UNITED STATES PATENT AND TRADEMARK OFFICE

Office Action Summary	Application No. 10/627,623	Applicant(s) UNGER ET AL.	
	Examiner Ernesto Garcia	Art Unit 3679

DETAILED ACTION

Woodruff et al., 6,309,524

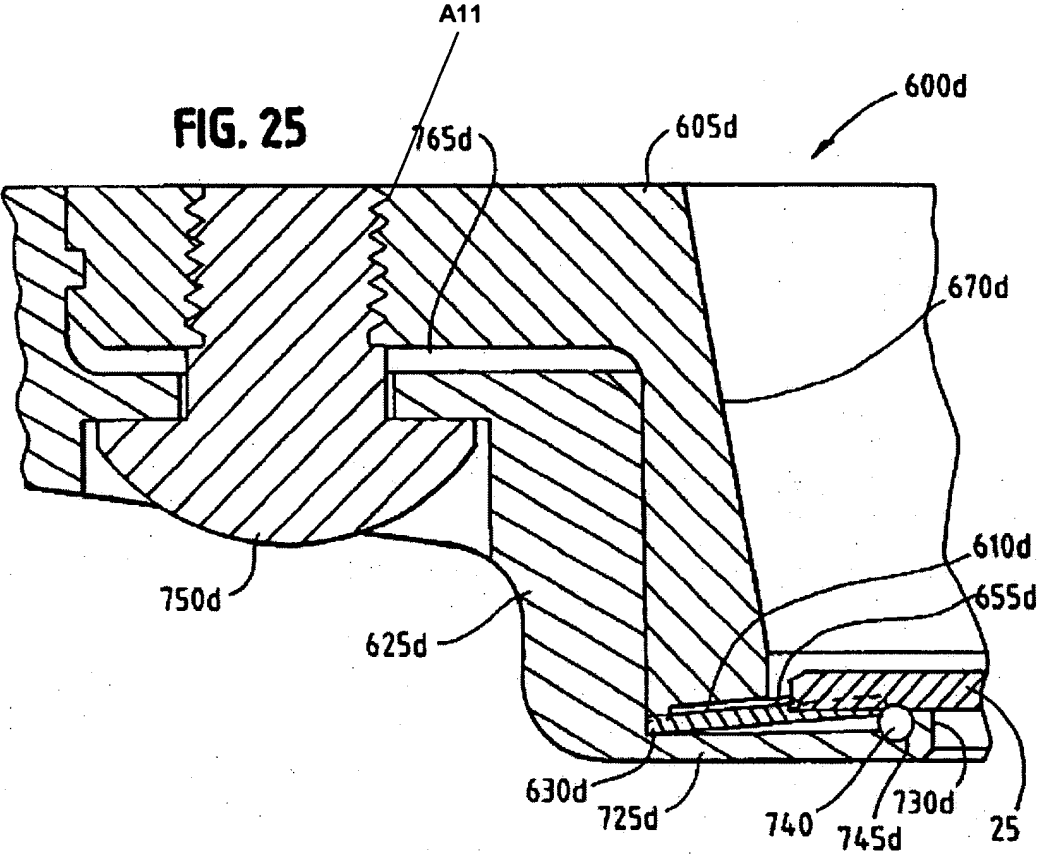
Regarding claim 10, Woodruff et al. disclose, in Figure 25, a securing device comprising a spring **610d**, a generally annular spring support **625d**, a generally annular coupling ring **605d**, and threaded holes **A11** in the coupling ring **605d**. The spring support **625d** includes a spring mount **725d** projecting in an inner side **765d** of the spring support **625d** and configured to support the spring **610d**.

Regarding claim 14, the threaded holes **A11** are at an interval of approximately 90 degrees or 180 degrees on the coupling ring **605d**.

Brunais et al., 4,333,434

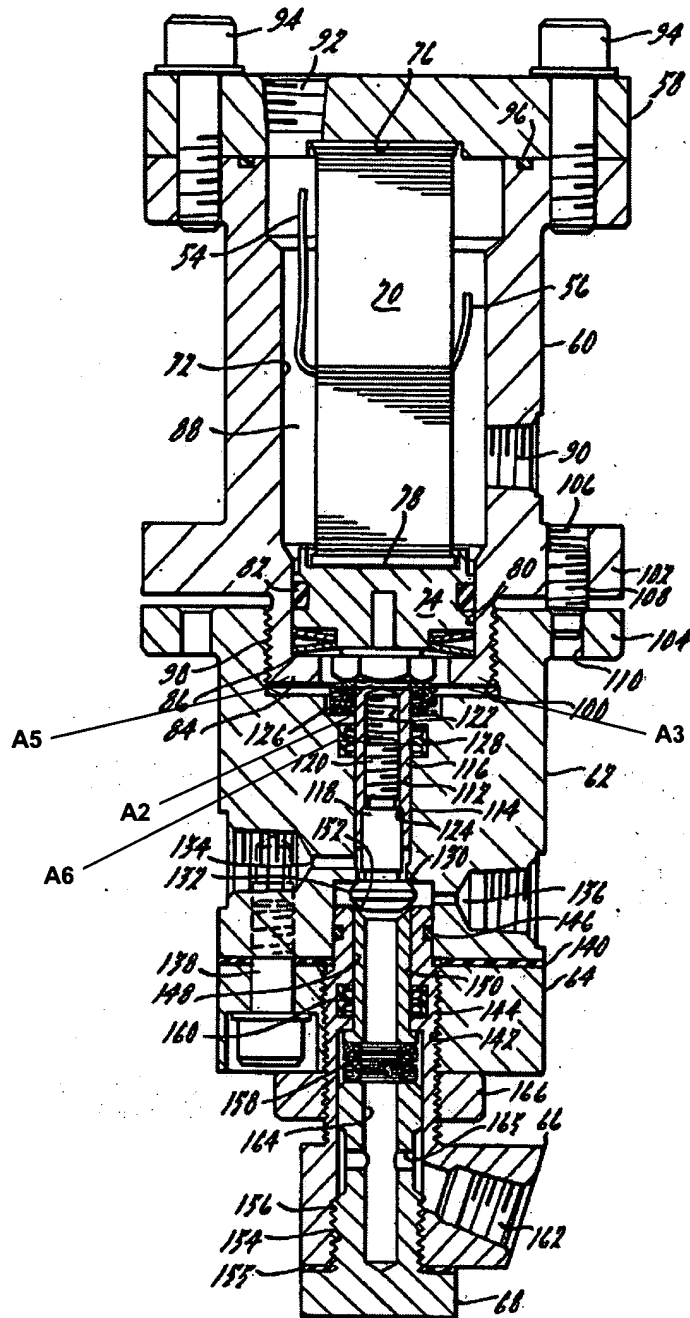
Regarding claim 10, Brunais et al. disclose, in Figure 2, a securing device comprising a spring **126**, a generally annular spring support **62**, a generally annular coupling ring **60**, and threaded holes **106** in the coupling ring **60**. The spring support **62** includes a spring mount **A2** projecting in an inner side **A3** of the spring support **62** and configured to support the spring **126**.

Regarding claim 11, the spring support **62** has a first inner diameter **A5** and second inner diameter **A6**. The spring mount **A2** radially inwardly projects at a region between the first inner diameter **A5** and the second inner diameter **A6**.

Regarding claim 12, a first thread **100** is formed on an inner periphery of the spring mount **A2**. A second thread **98** is formed on an outer periphery of the coupling ring **60**.

Regarding claim 14, the threaded holes **106** are at an interval of approximately 90 degrees or 180 degrees on the coupling ring **60**.
